MISSION BAY SUBSEQUENT ENVIRONMENTAL IMPACT REPORT

PLANNING DEPARTMENT FILE NO. 96.771E

VOLUME III: SUMMARY OF COMMENTS AND RESPONSES

MISSION BAY SUBSEQUENT EIR
 FIGURE V.B.2 (REVISED) LAND USE IN THE PROJECT AREA AND VICINITY

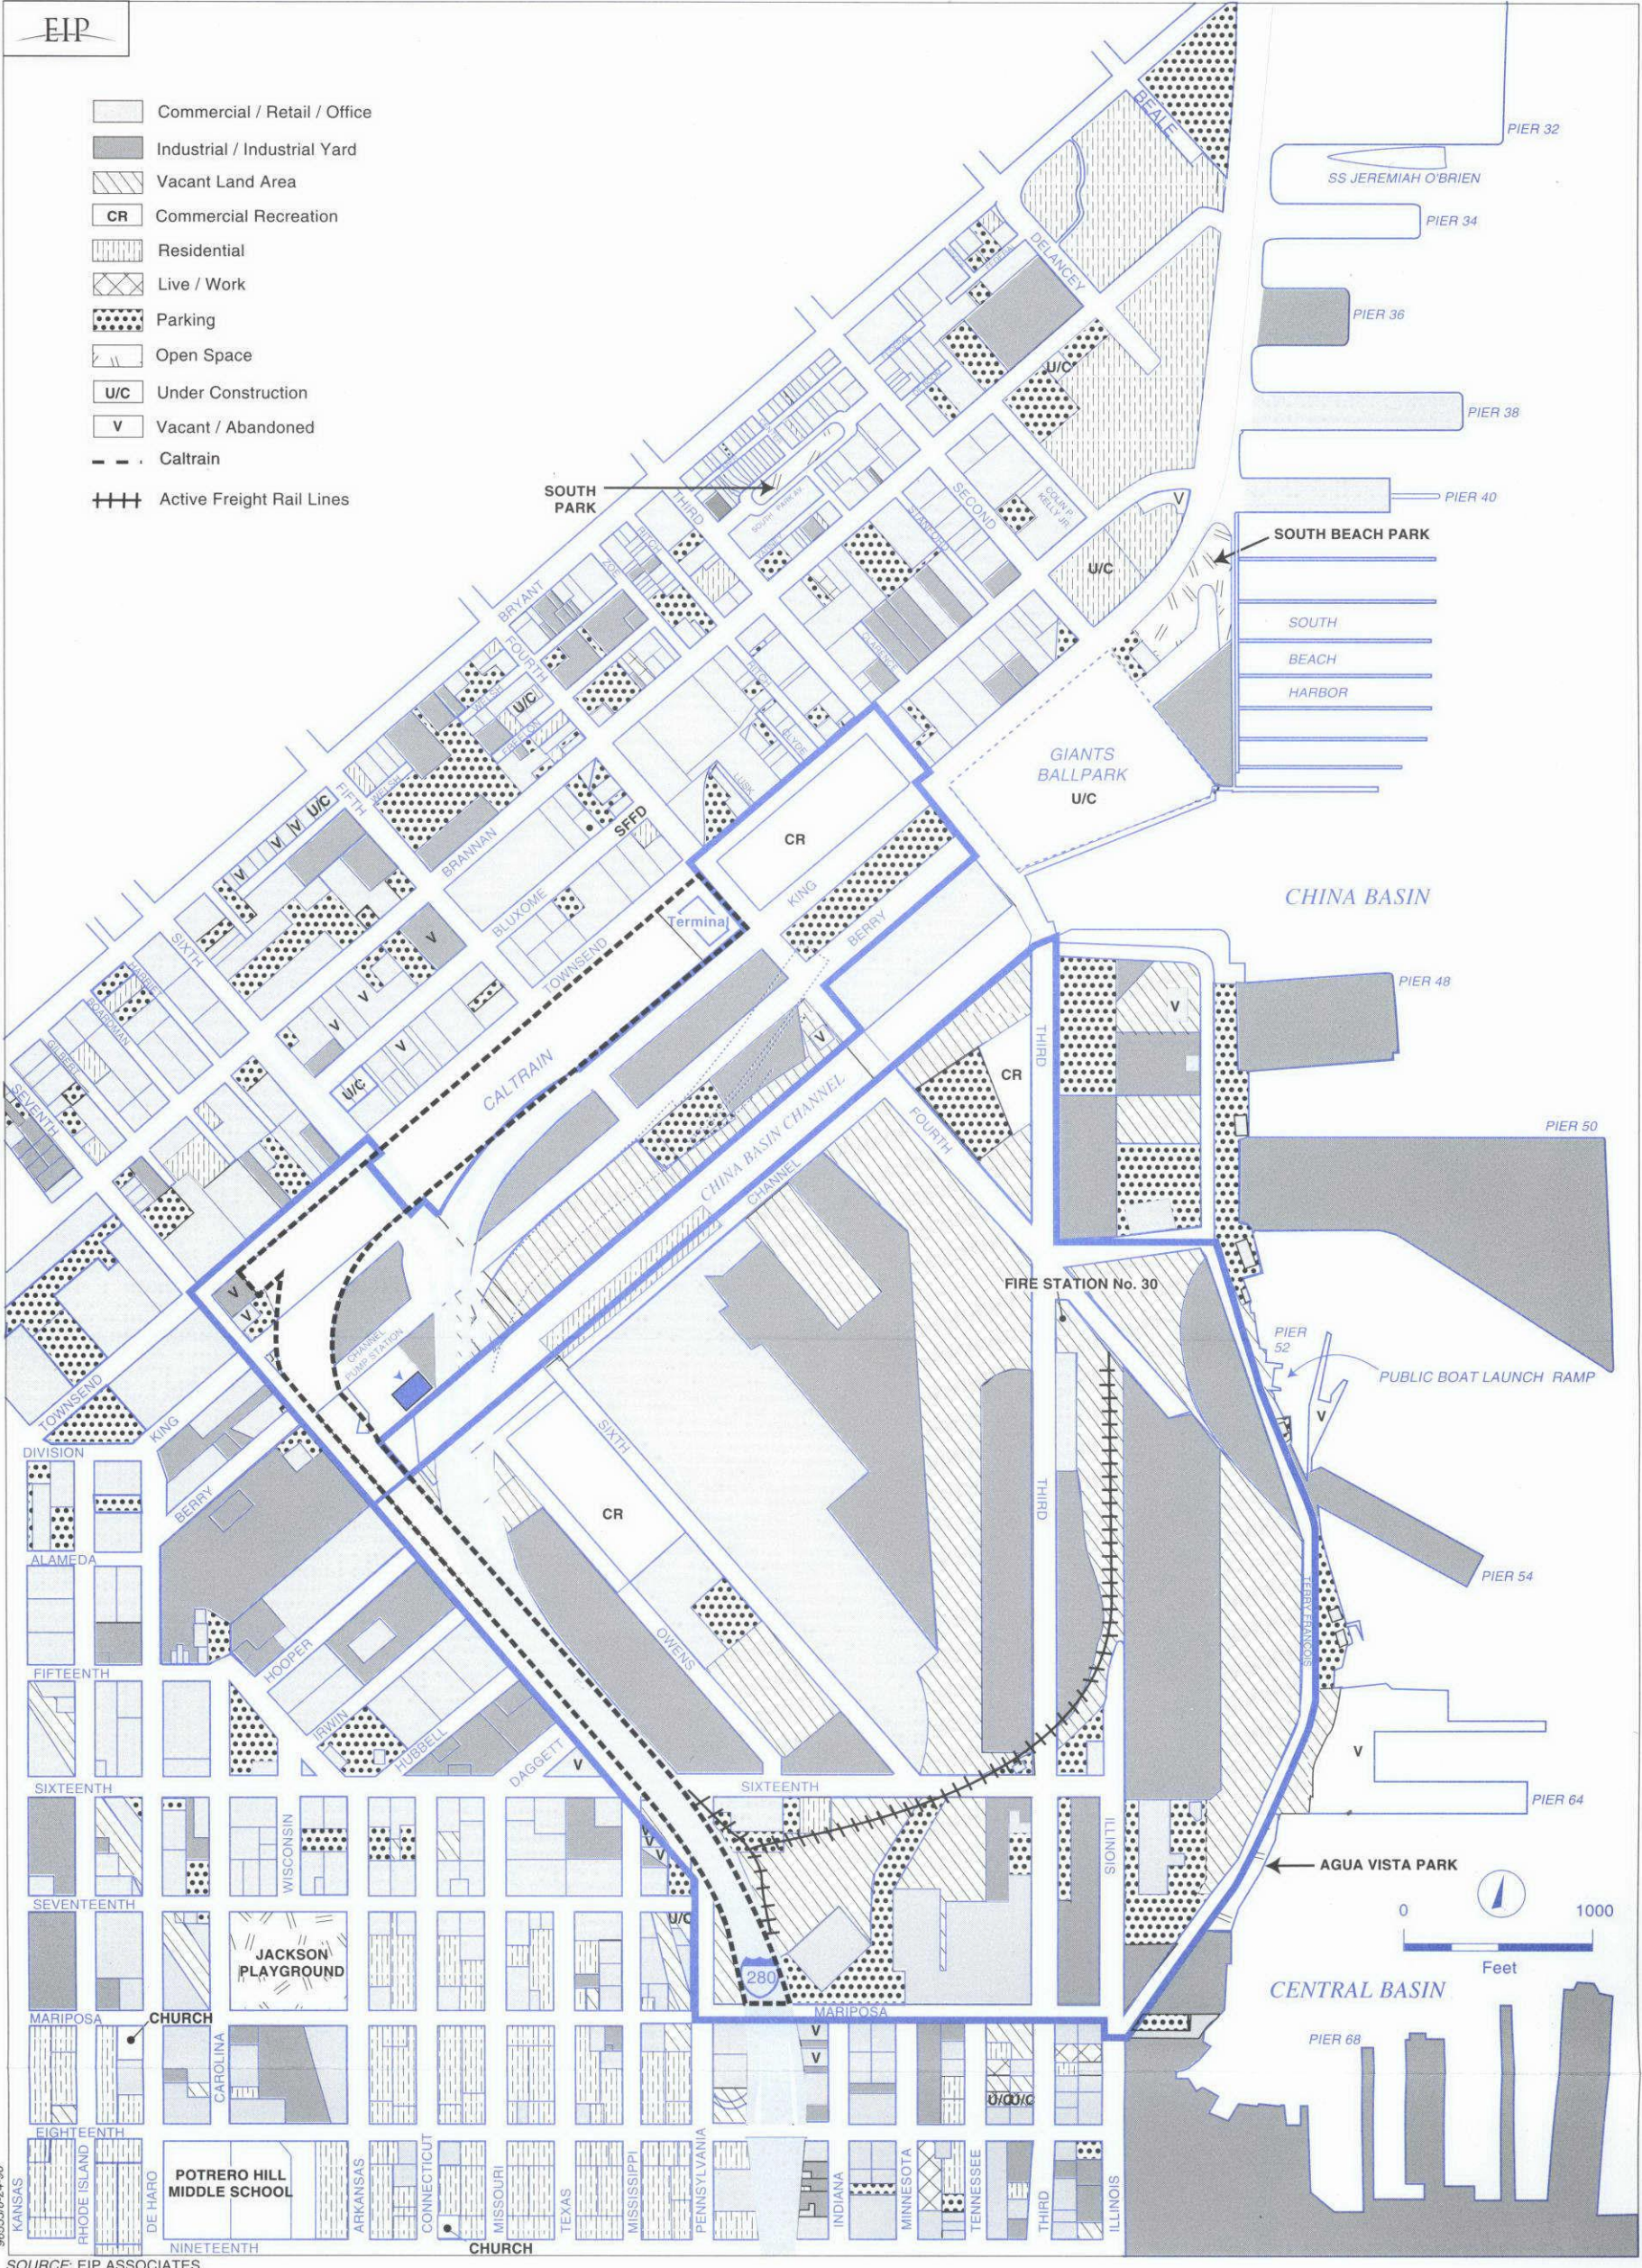
Many of the figures in the DEIR show the existing Caltrain right-of-way as some use other than railroad. No portion of the Caltrain right-of-way has been vacated or abandoned (Figure V.B.2). The figures should be clarified to show that Caltrain intends to continue occupying all of the property for the purpose of operating train service indefinitely. Caltrain is now in the process of developing plans to reconfigure and improve its track, signals, buildings and other facilities at its 4th and Townsend Street terminal. (*Darrell J. Maxey, P.E., Chief Engineer, Caltrain*)

Figure V.B.2: Active railroad right-of-way (the “wye” junction from the Caltrain tracks between Sixteen and Mariposa Streets leading to Illinois Street) is incorrectly marked as having an existing land use of “Parking” or “Vacant.” (*Richard Mlynarik*)

As the comments suggest, Caltrain controls the right-of-way along Seventh Street; however, the underlying title is held by Catellus, as shown in Figure III.B.2. The Caltrain right-of-way is appropriately designated public facilities in Figure III.B.3, which shows the Land Use program. Figure V.B.2 shows parking and open land area over the active tracks since they are in use during the day. As noted in the response in Land Use, "Active Freight Rail Lines" on p. XII.51, Figure V.B.2 is amended to designate the active rail freight lines.

Figure V.B.2, Land Use in the Project Area and Vicinity, does not indicate the “y” junction from Seventh Street to Illinois Street (which is correctly indicated on Figure V.E.7). The legend of Figure V.B.2 is amended to include “Active Freight Rail Lines.” The active freight rail lines replace open land area and parking uses extending northeast from I-280 at 17th Street, across 16th Street, through the northwest corner of Third Street and 16th Street, across Third Street, into the Illinois right-of-way north to Mission Rock Street.

**FIGURE VI.2 (REVISED) WEEKDAY P.M. PEAK HOUR LEVELS OF SERVICE:
YEAR 2015 CUMULATIVE, MITIGATED**

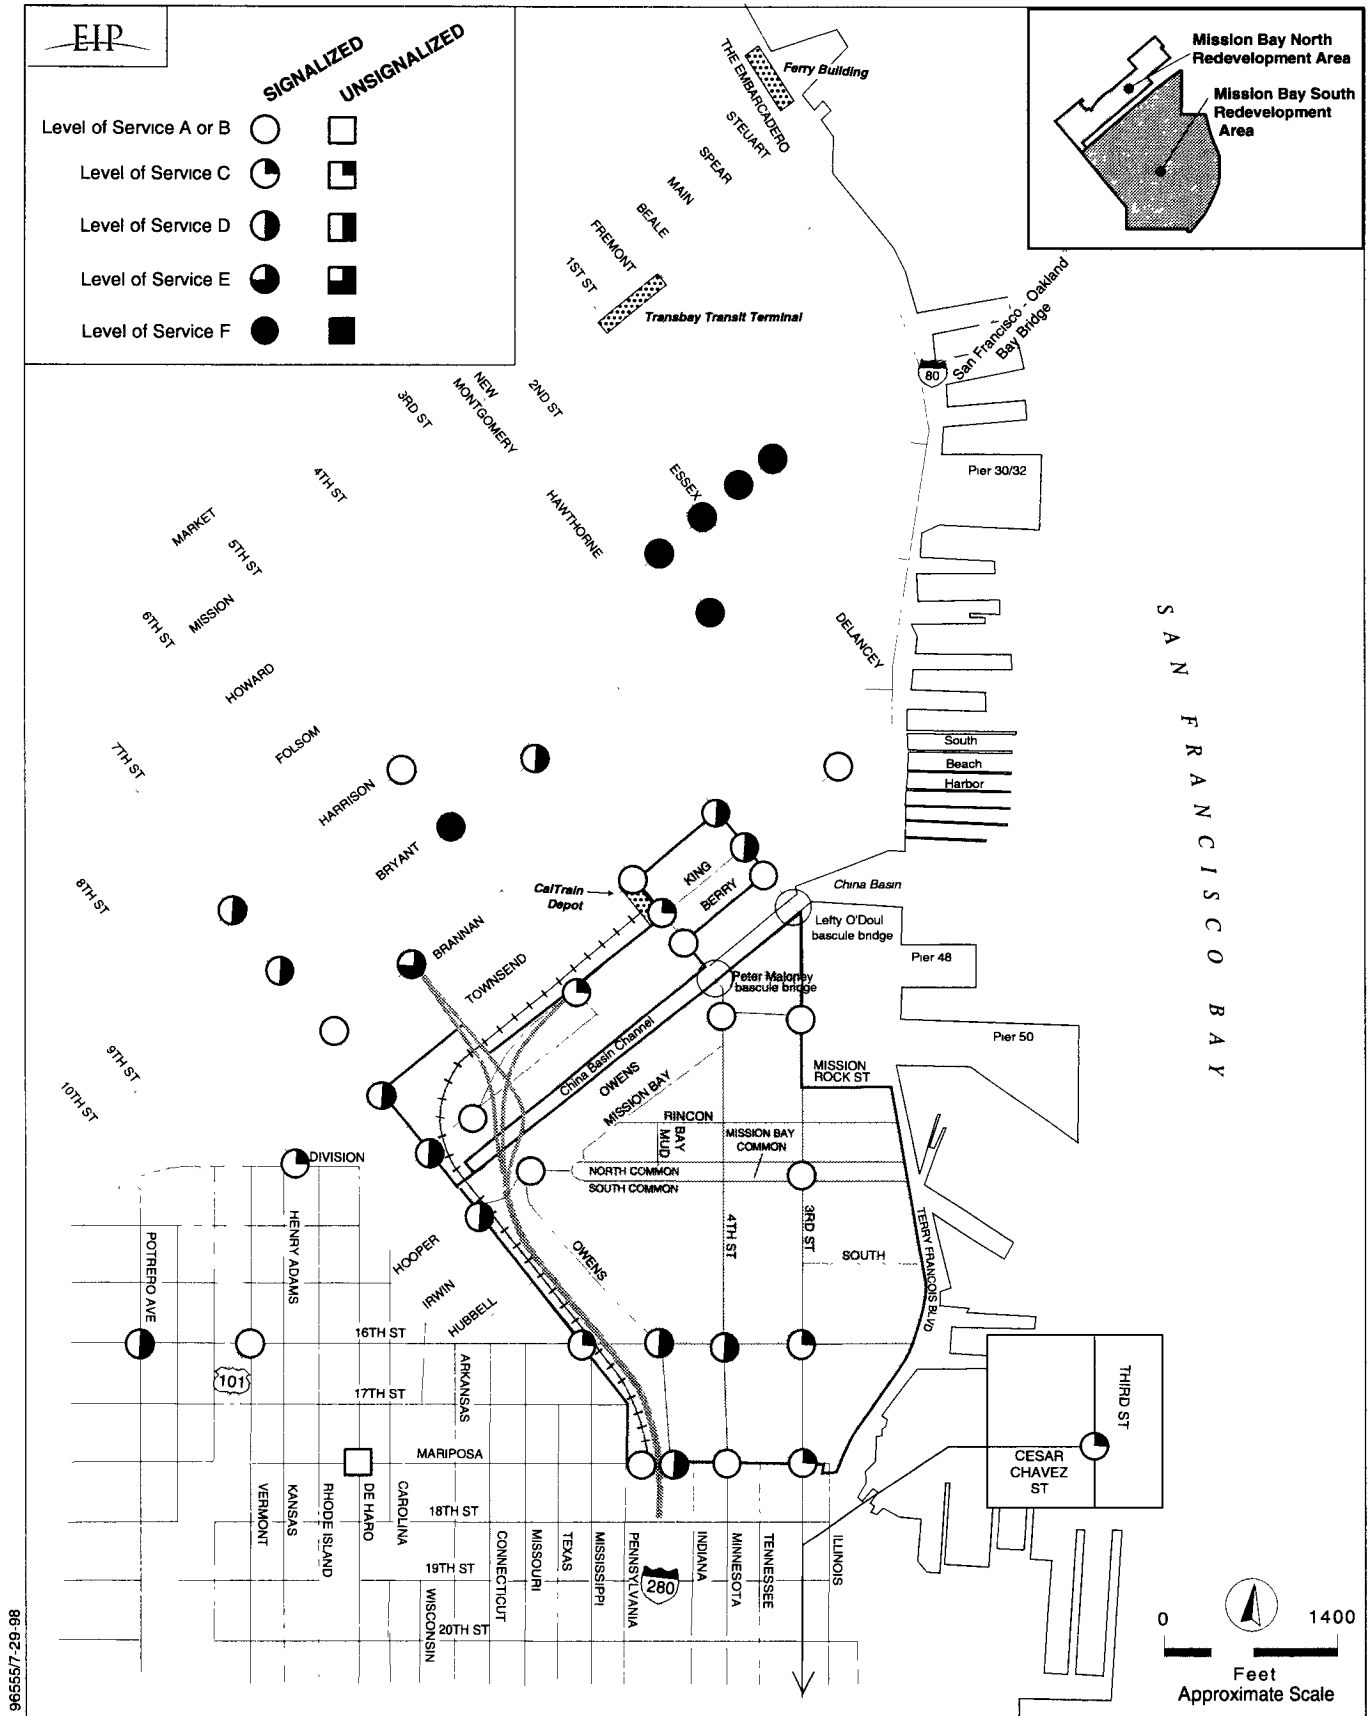
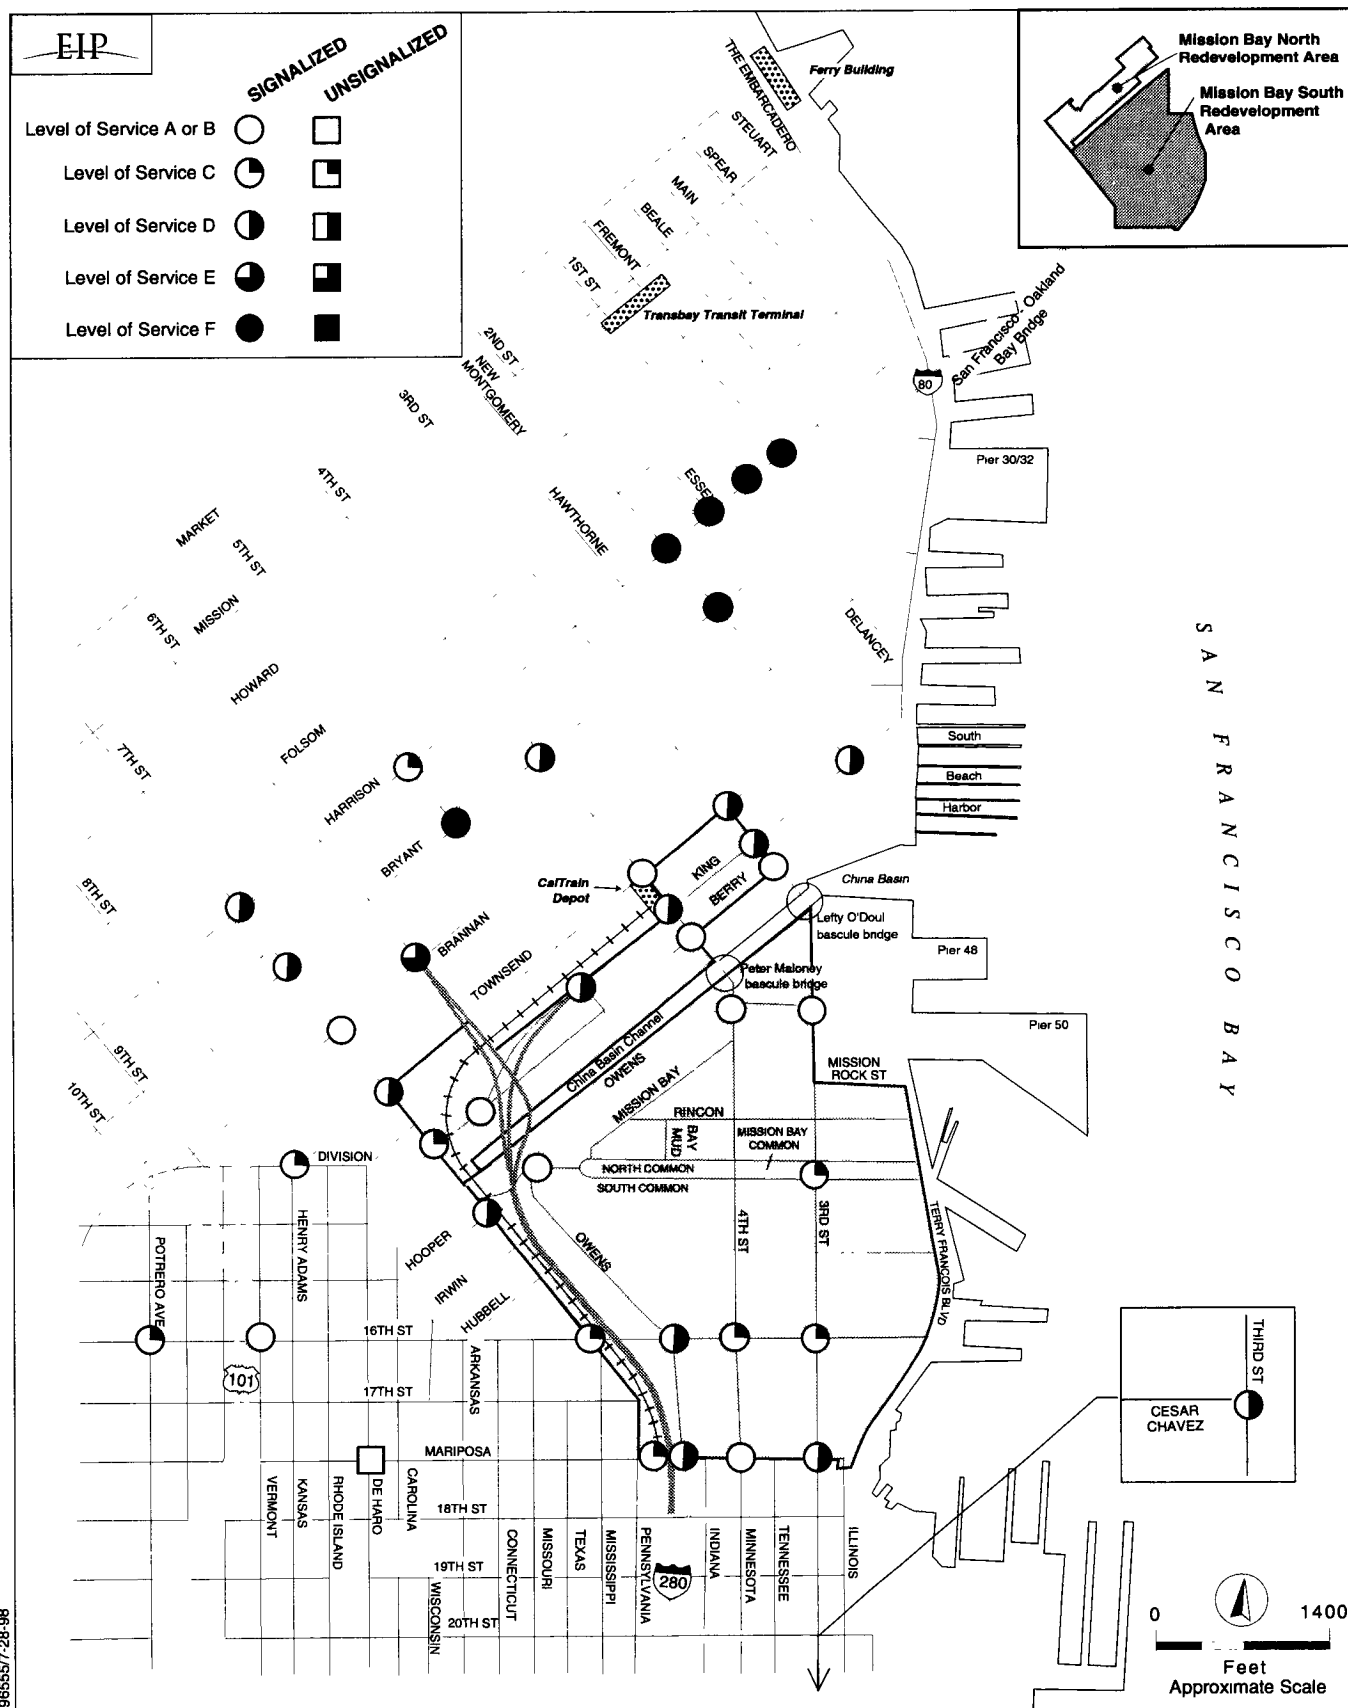
Figure VI.2: LOS indications for the Fourth/King and Fourth/Brannan intersections are not shown (but are present in the corresponding Figure VI.1). Also, figure VI.2 (project cumulative) shows the King/Berry intersection at LOS "C" when it was already at level "D" in Figure VI.1 (existing plus project). This cannot be correct. (*Richard Mlynarik*)

A level of service (LOS) for the intersection of Fourth and Brannan Streets was shown in error on Figure VI.1. This intersection is not a study intersection, and the figure has been corrected to eliminate the LOS marker for this intersection. The LOS marker for the intersection of Fourth and King Streets was inadvertently not shown on Figure VI.2. The intersection of Fourth and King Streets is expected to operate at LOS D under cumulative mitigated conditions. Figure VI.2 has been corrected to indicate this. Both corrected figures are shown on pp. XII.169 and XII.170.

The level of service for the intersection of King and Berry Streets is shown as operating at LOS B under both Existing With Project Mitigated conditions and Year 2015 Cumulative Mitigated conditions. The comment is most likely referring to the intersection of Berry and Seventh Streets, that is shown to operate at LOS D under Existing With Project Mitigated conditions, and to operate as LOS C under Year 2015 cumulative mitigated conditions. These LOS calculations are correct. Under the Existing-With-Project conditions, the intersection would operate at LOS D, and therefore would not require a mitigation measure. However, after adding cumulative traffic growth to the intersection, the operation of the intersection would degrade to LOS F (see p. V.E.69), therefore requiring mitigation. The application of the mitigation measure described in Table VI.5 on p. VI.22 would improve the operation of the intersection to LOS C; therefore, Figure VI.2 is correct in showing the Berry and Seventh Streets intersection at LOS C.

**FIGURE J.1 (REVISED) SAN FRANCISCO CLEAN WATER PROGRAM
COMBINED SEWER SYSTEM CONCEPTUAL DIAGRAM**

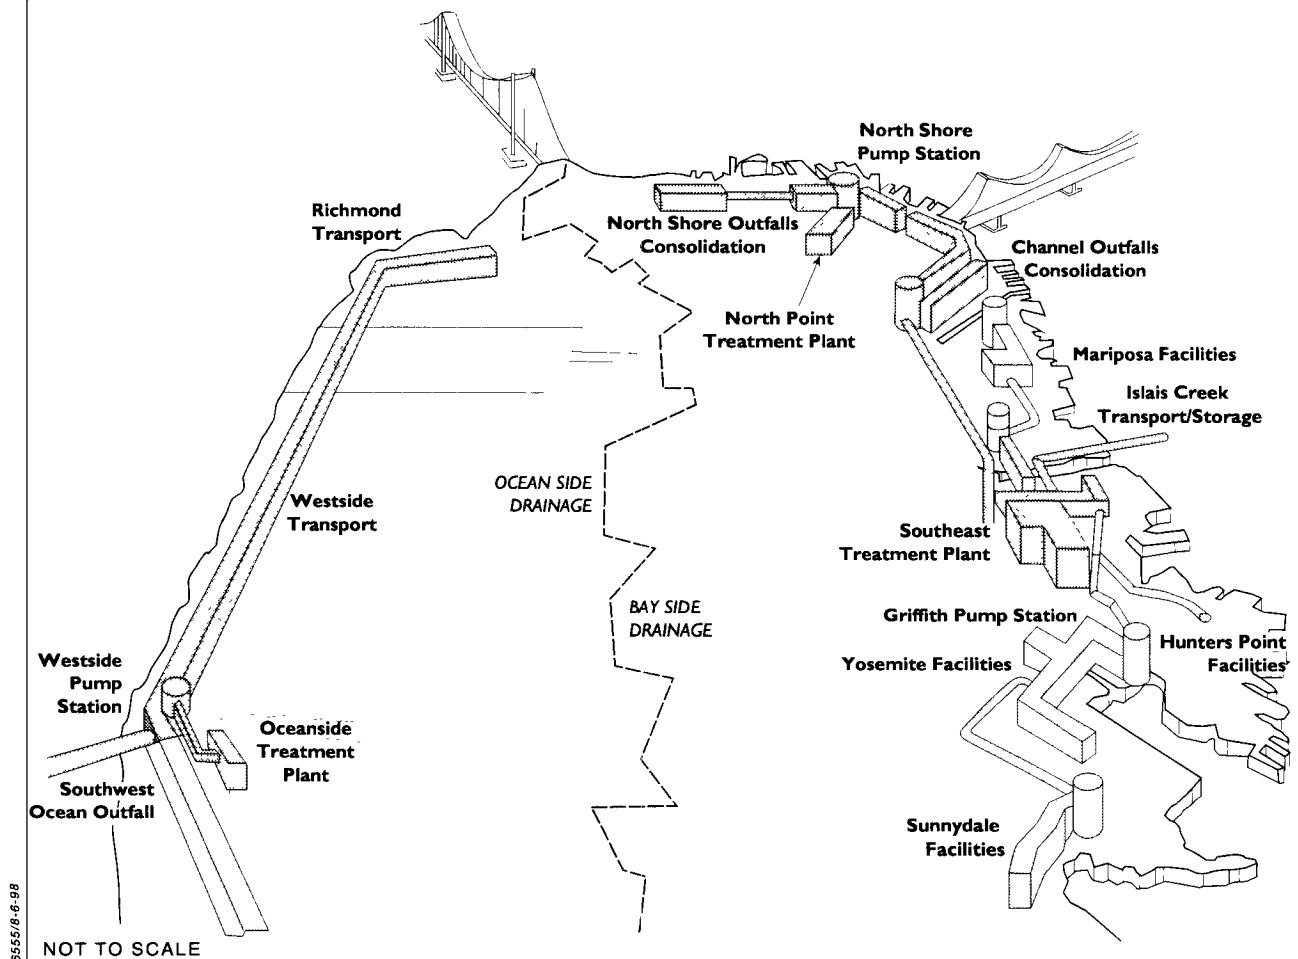
[T]here seems to be an oversight in Figure J.1, of Volume III. The map of San Francisco, which illustrates the Cities' waste treatment system shows a "Cross Town Tunnel (not yet scheduled for construction)." The Board of Supervisors has stated in a resolution last year that this is no longer a feasible solution to expanding the system and that the city will not be considering this option in the future. Therefore, it should be removed from the figure and any reference to it omitted. (*Michael J. Paquet, Environmental Committee Chair, Surfrider Foundation, San Francisco Chapter*)

And first I'd like to also state the oversight of the cross-town tunnel being in the report in Figure J-1, very back end of the third volume.

These comments recommend revising Figure J.1 on p. J.2 of Appendix J, Hydrology and Water Quality, to eliminate the reference to a cross-town tunnel. The *San Francisco Wastewater Master Plan* includes a cross-town tunnel to transport wastewater from the Bayside to the oceanside. In 1974, when the Wastewater Master Plan was adopted, wastewater discharge standards were changing rapidly, and the City believed future restrictions on wastewater discharges to the Bay could necessitate this major capital project. However, the Regional Water Quality Control Board never required the construction of the tunnel as a National Pollutant Discharge Elimination System (NPDES) permit requirement, and San Francisco now complies with its NPDES permit requirements. See also the responses regarding “Background Regarding the Existing Combined Sewer System” on pp. XII.232-XII.238 and “Wet-Weather NPDES Permit” on pp. XII.371-XII.376. The San Francisco Board of Supervisors has not adopted formal legislation to remove the cross-town tunnel from the Wastewater Master Plan, but the tunnel is no longer considered a foreseeable option for future wastewater management./27/ As discussed in the response regarding “New Water Quality Standards” on p. XII.371, future changes to discharge standards cannot be anticipated; however, if new standards are ever promulgated that substantially affect the City’s ability to discharge wastewater to the Bay, the City would likely study reasonable options and alternatives to achieve the new discharge requirements at that time. Because the cross-town tunnel is no longer reasonably foreseeable, Figure J.1 has been revised as shown on the next page to remove the reference to it.
